# UNITED STATES PATENT AND TRADEMARK OFFICE

APPLICATION NO.	FILING DATE	FIRST NAMED INVENTOR	ATTORNEY DOCKET NO.	CONFIRMATION NO.
10/646,094	08/22/2003	Richard L. Dubay	D398.12-0001	8387

<b>Office Action Summary</b>	Application No. 10/646,094	Applicant(s) DUBAY, RICHARD L.	
	Examiner Matthew Johnson	Art Unit 3682

## **DETAILED ACTION**

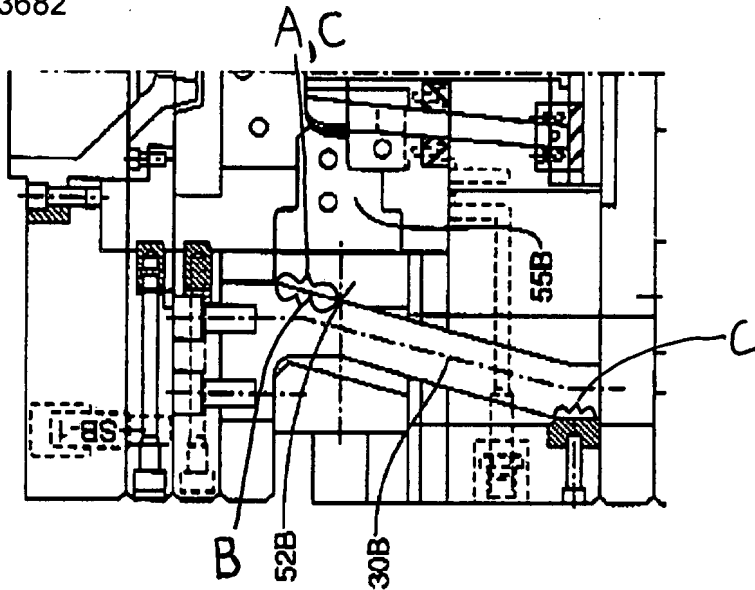
- Cam lever (30a-d) mountable to a second die block half (12) and removably insertable into the slide during a molding or casting cycle (C6 L51-54), the cam lever comprising a head (Fig. 2 mounted in plate 22) and a tail (Fig. 2 protrusion from the head) having a first cam flat surface (B, see attached figure below) extending from the head at the oblique angle for insertion into the slot; wherein the cam lever is adapted to move the

slide relative to the base through cam action (C6 L 22-28 & L47-54) and wherein the first cam flat surface of the tail flushly abuts the first slide flat surface of the slot to retain position of the slide relative to the first die block half during an injection phase of the molding or casting cycle (Fig. 5)
